252-256 Main Street SPSP Application

RE: Comments on Site plan special permit application (SPSP 09/11/15-457) for 252-256 Main Street, 110 Grill

Subject: Site Plan Special Permit – 110 Grill – 252-256 Main St – SPSP #09/11/15-457

To: Board of Selectmen **Date:** October 26, 2015
From: Kristen Guichard, AICP, Assistant Town Planner *KAG*
Subject: Site Plan and Use Special Permit Application #9/11/15 - 457

3,000 GALLON GREASE TRAP DETAIL
NOT TO SCALE

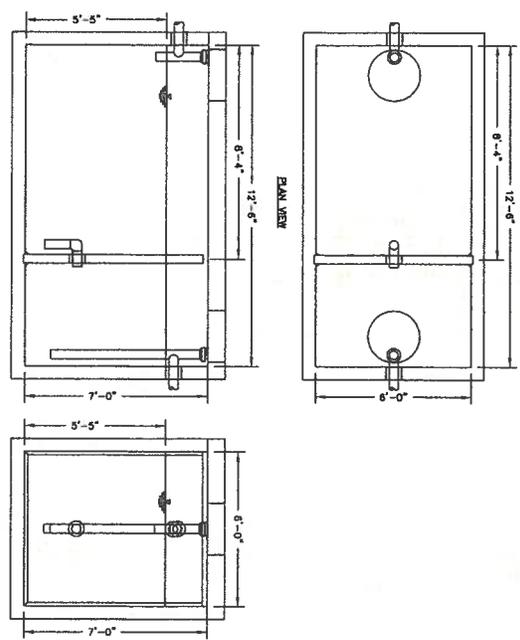
1. A plan review of the proposed restaurant will be required by the Health Department prior to construction along with application and fee.
2. The external grease trap must be upgraded to accommodate the increase in seats – 750 gallons provided; 3600 gallons required
3. The dumpster must be surrounded by a fence and equipped with a lockable gate. The dumpster must be licensed by the Health Department on a yearly basis.
